TO: Dr. Jesse Bacon, Superintendent
FROM: Danny Clemens, Director of Facilities
Date: August 19, 2024
RE: BEHS Fine Arts - Change Order 11 -Added Parking Lot and Softball Field
Demolition **DC**

Bullitt East High School Fine Arts Addition
11450 KY-44, Mt Washington, KY 40047

Change Order Number: 011

REQUEST FOR PROPOSAL

C1.2

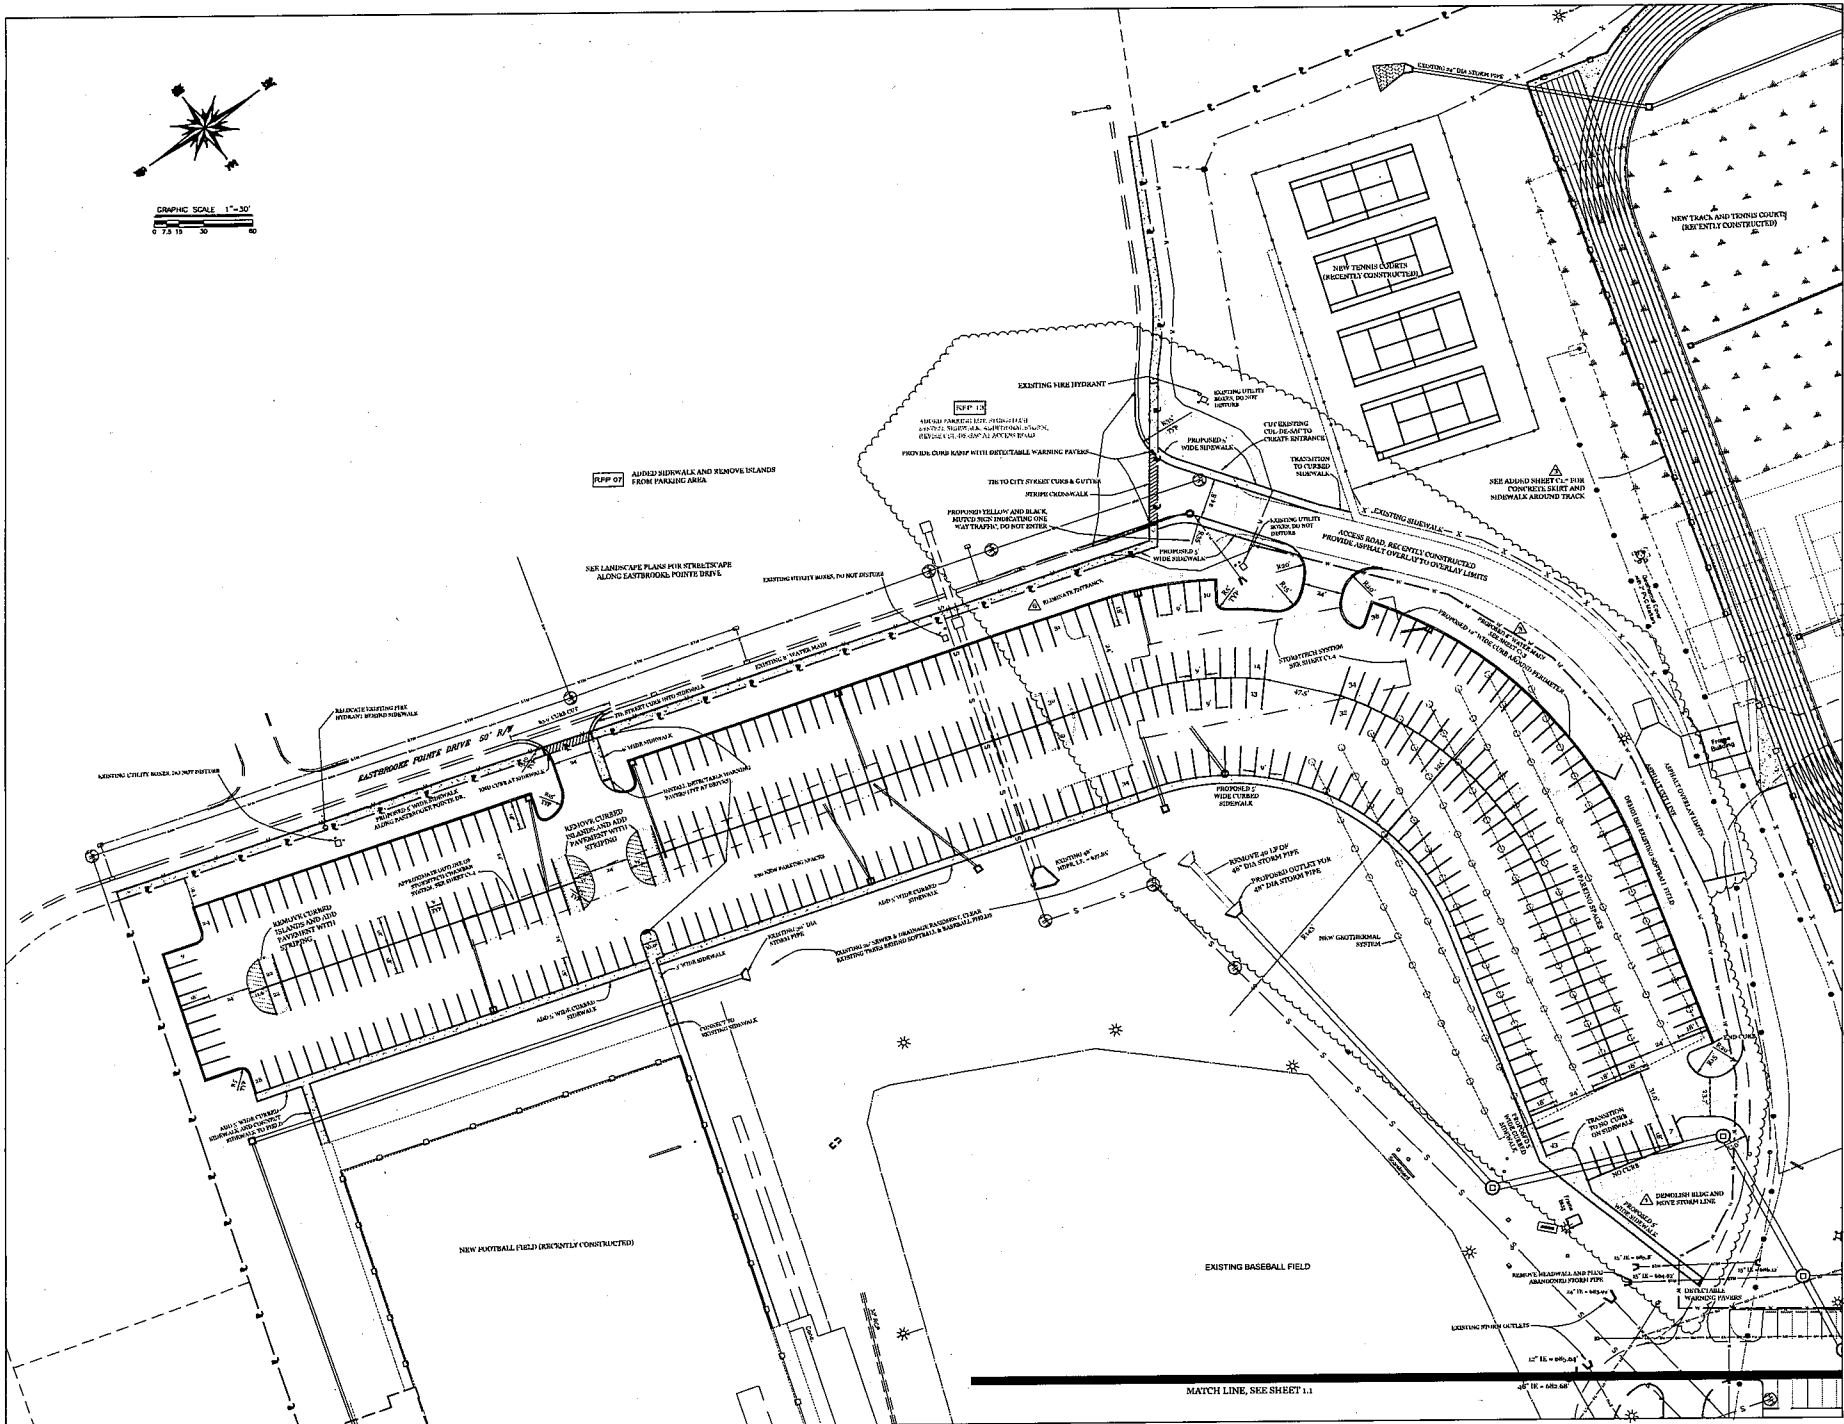
- Item 1:** Expand parking lot over existing softball field and proposed geothermal field, as shown, including extension of sidewalk. Include two access points to access road. Proposed contours have been provided.

C1.3

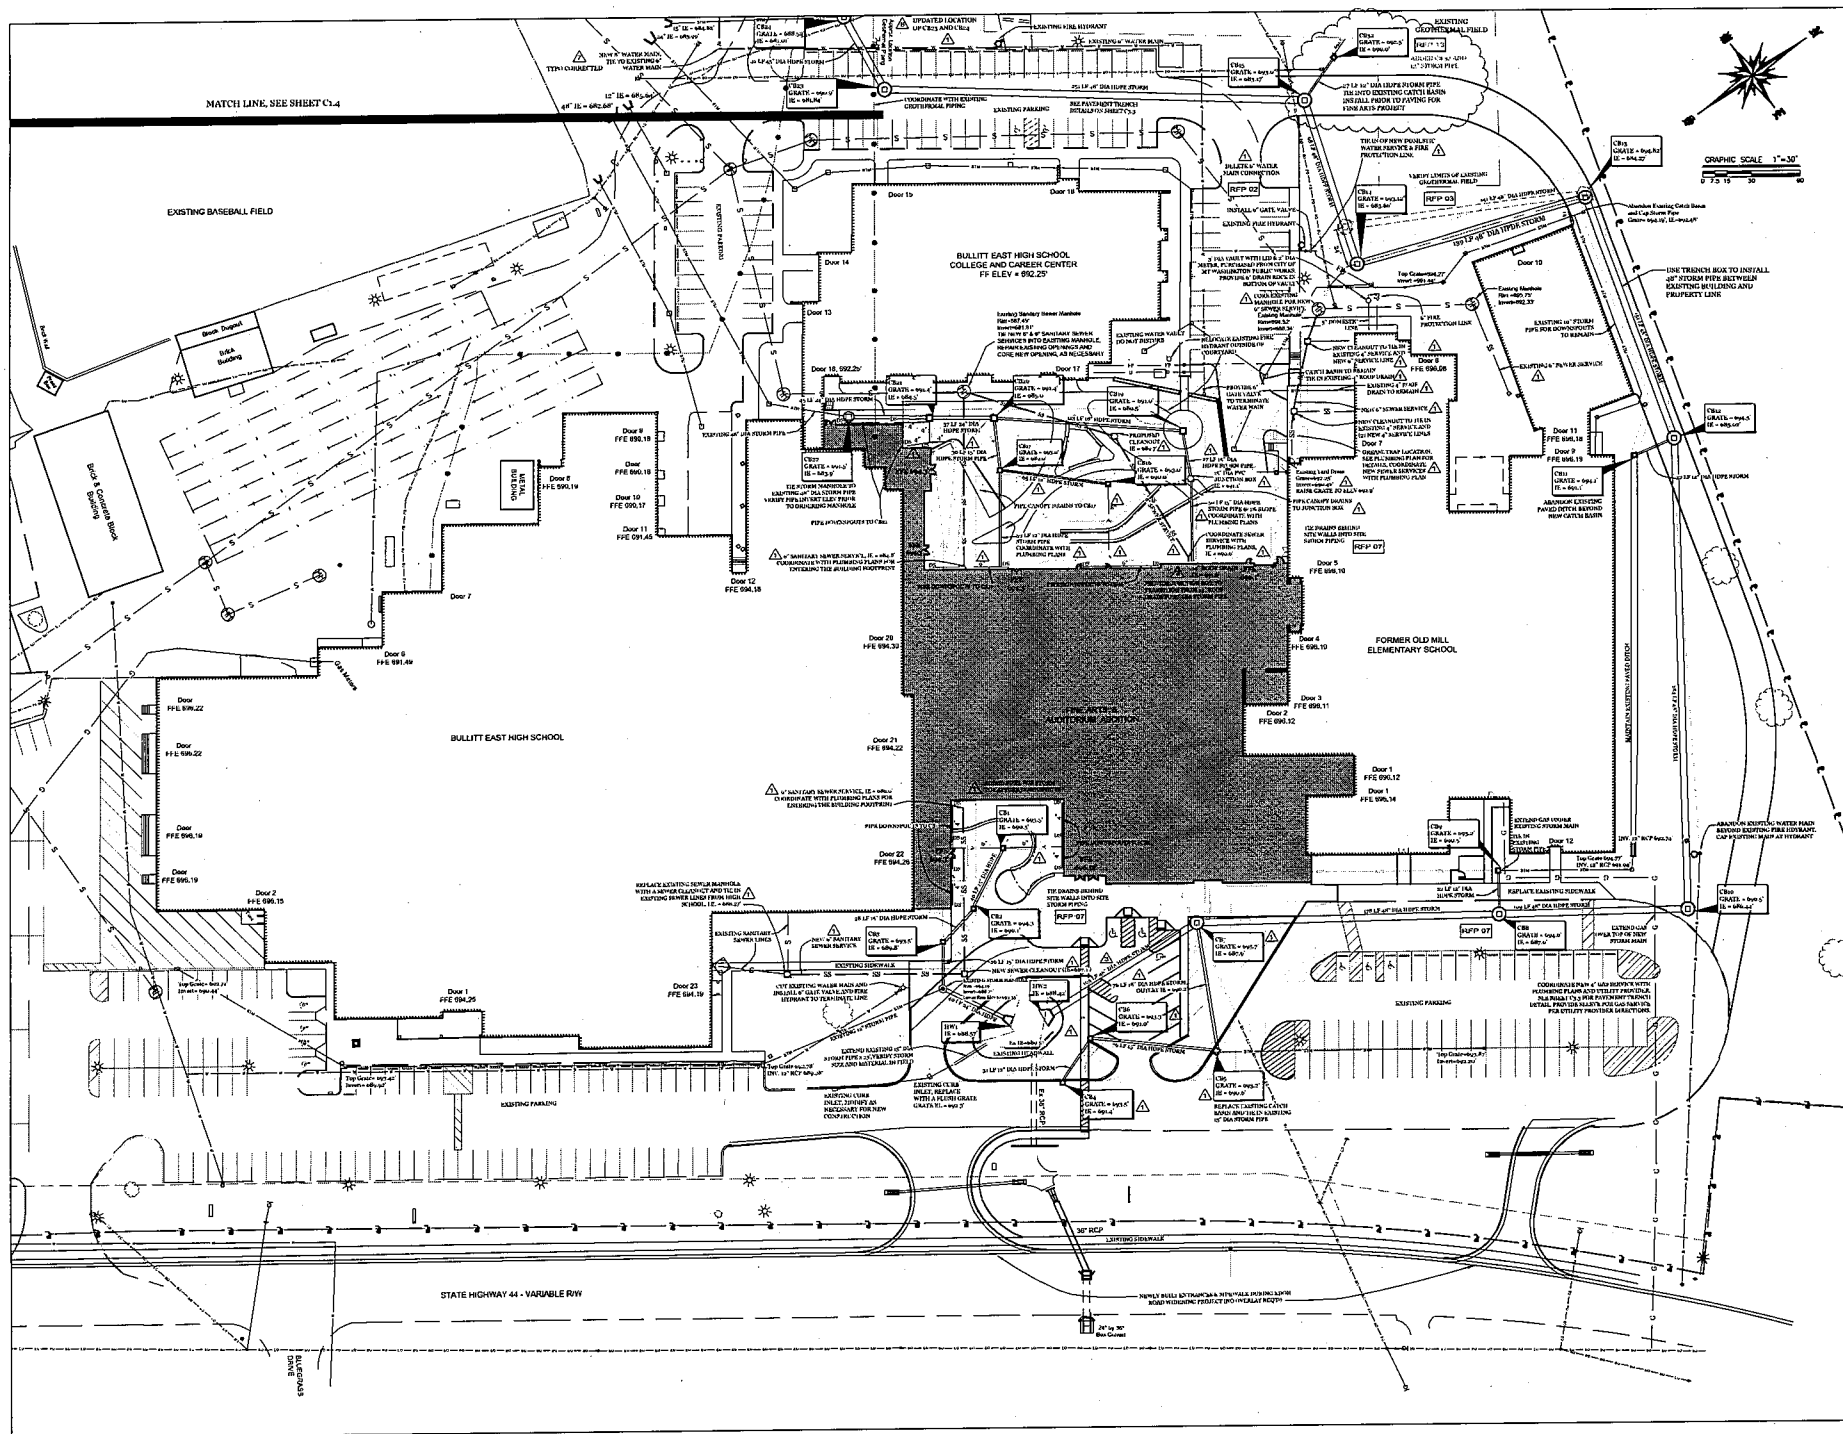
- Item 2:** Provide storm system for new parking lot including StormTech detention system. Details of StormTech system are included in the second attachment to this RFP.

- Item 3:** Remove 40 lf of 48" storm pipe and place headwall in new location.
- Item 4:** Remove portion of cul-de-sac and create entrance to existing access road. Tie in sidewalk and provide crosswalk. Replace existing catch basin with new curb inlet adjacent to sidewalk. Provide asphalt overlay on access road past entry to existing running track.

C1.4

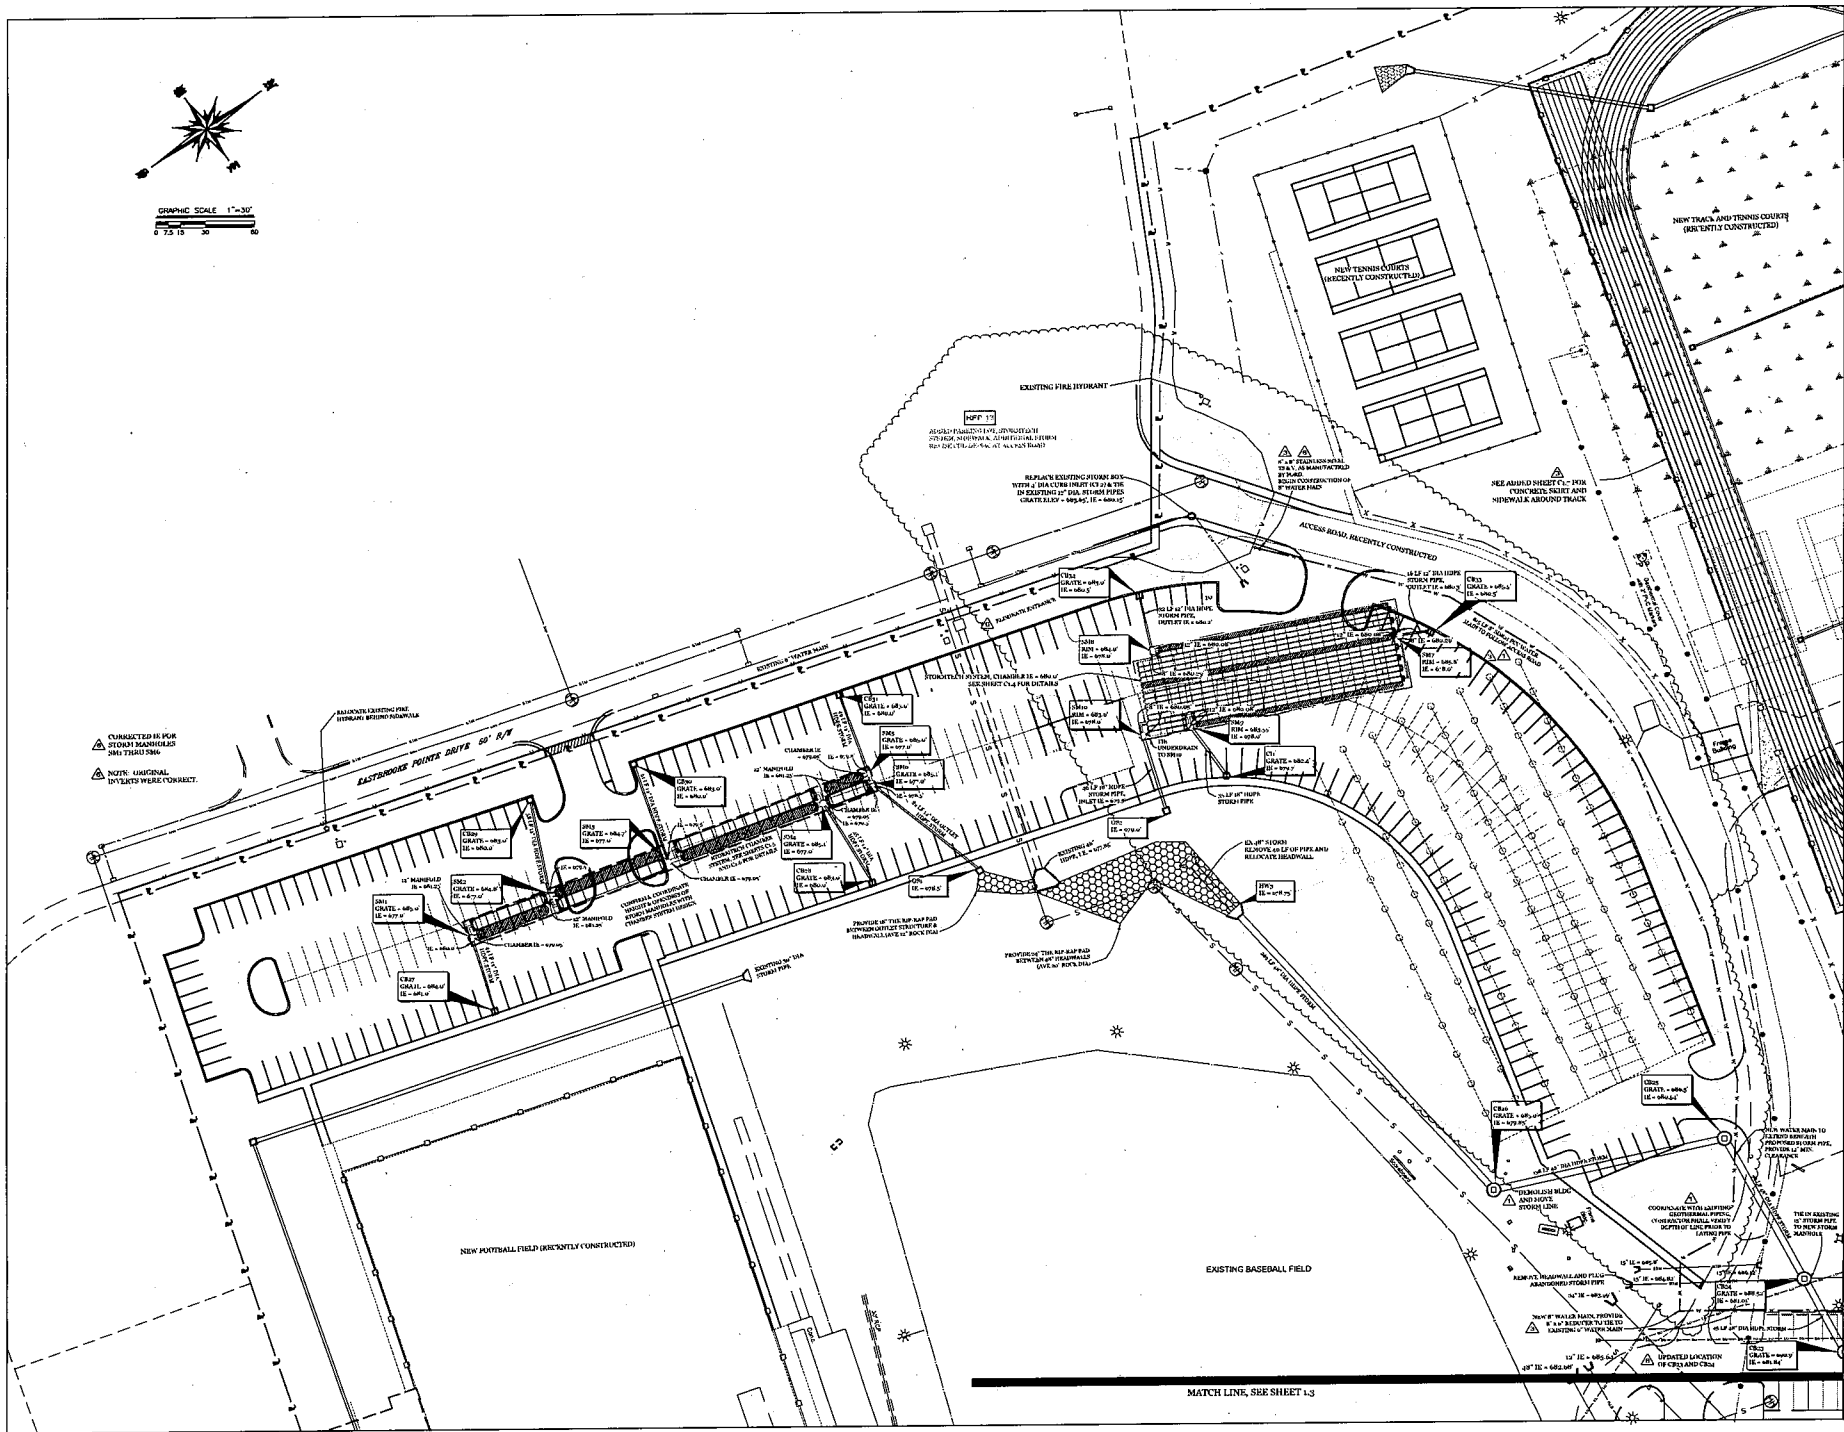
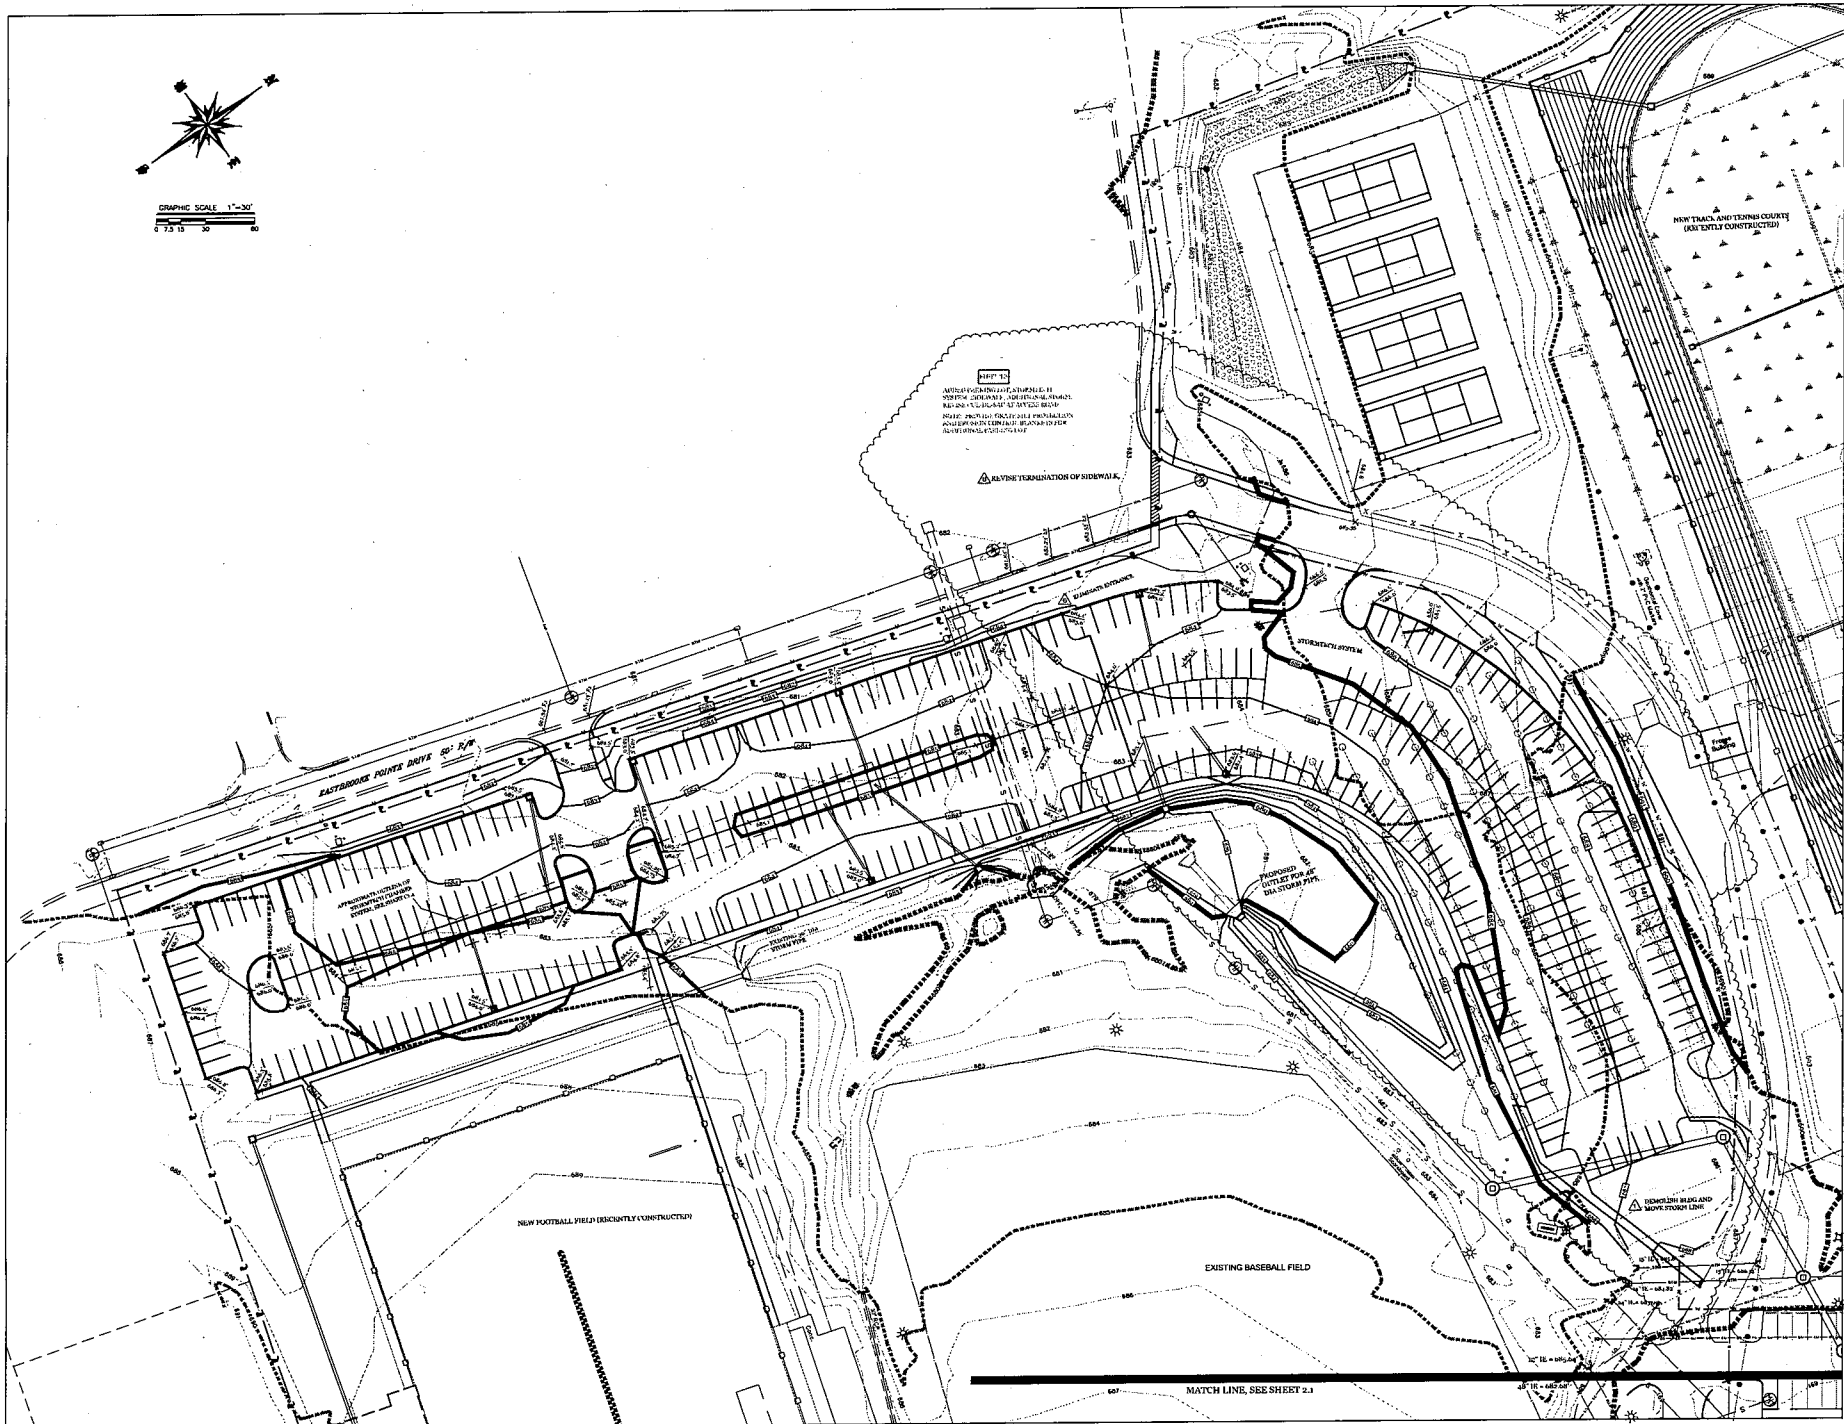
△ CORRECTED IN FOR STORM MANHOLES AND TRENCHING.
 △ NOTE: ORIGINAL DETAILS WERE CORRECT.
